Re: **PETITION NO. 1218** - PSEG Power Connecticut LLC petition for a declaratory ruling that no Certificate of Environmental Compatibility and Public Need is required for the construction, maintenance, and operation of a new 485 megawatt (MW) dual fuel combined-cycle electric generating facility at the existing Bridgeport Harbor Station located at 1 Atlantic Street, Bridgeport, Connecticut

Enclosed please one original and fifteen (15) copies of PSEG Power Connecticut LLC's ("PSEG") additional responses to the Connecticut Siting Council's interrogatories from December 9, 2016 related to PSEG's D&M Plan – Phase II.

**Bridgeport Harbor Station Oil Dock – Center Breasting Dolphin**  
**March 8, 2016**  
**Looking Southeast**

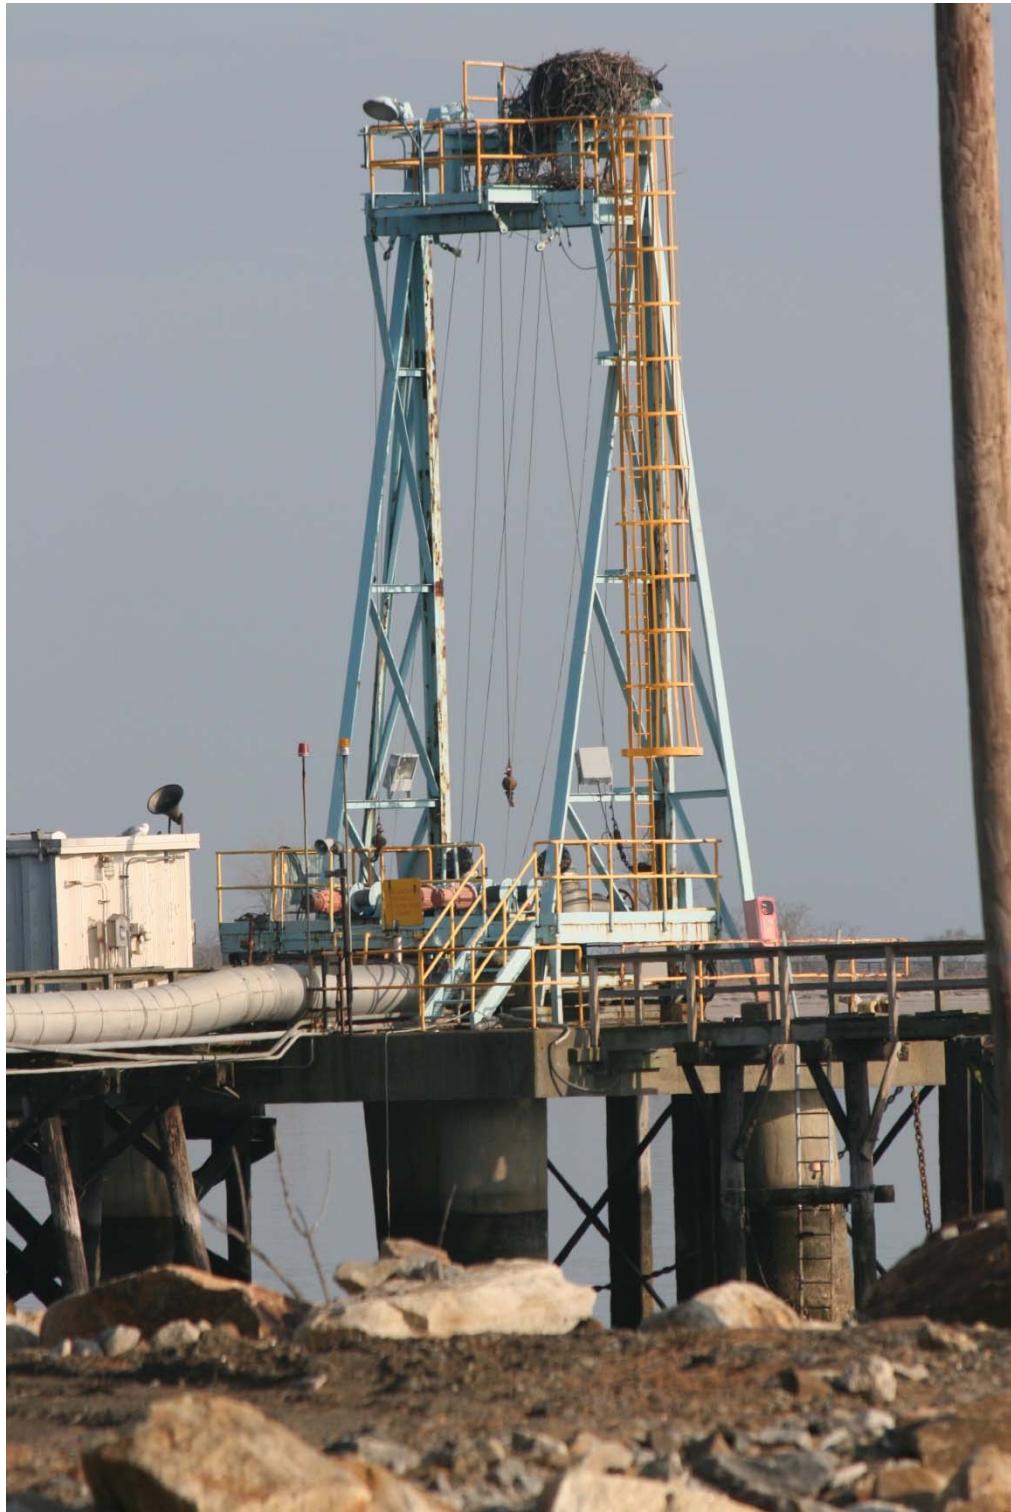
**CSC-D&M-19. Reference PSEG Power Connecticut LLC's (PSEG) response to interrogatory 14 for the Phase II Development and Management Plan (Phase II D&M Plan). Have osprey been recently observed on the existing nests in the vicinity of the oil dock?**

Yes, osprey nested on the Bridgeport Harbor Station (BHS) oil dock during the 2016 active nesting season. Exact dates were not logged, but the active nesting season is generally considered to be early to mid-March (when the birds return to the region and initiate nesting preparations), into the late summer and early fall, when the juvenile osprey fledge. There is not a “regulatory” timeframe; timing is established by the birds for each nest.

Osprey periodically nest on various elevated structures at the site. These structures include the center breasting dolphin oil gantry on the oil dock (see photographs below). Other locations where nests have been observed are the existing coal dock (coal unloading tower), the out-of-service east outer wing walkway on the oil dock, and the coal pile conveyor structures. These facilities are all currently or have recently been in-service on the BHS site, and no issues associated with the adjacent operational uses on nesting have been identified.

In early March 2016, PSEG notified and received CT DEEP acknowledgement that PSEG could remove the nest on the oil dock prior to the return of the osprey (i.e. prior to the nesting season). That nest was removed to ensure that temporary walkway repairs would not impact or disturb any nesting birds at that location. Upon the return of the osprey to the region later in the spring of 2016, the osprey re-established the nesting location and used it during the 2016 season. Walkway repairs were completed without identifying any avian issues. As noted above, osprey use was observed, but not tracked or logged.
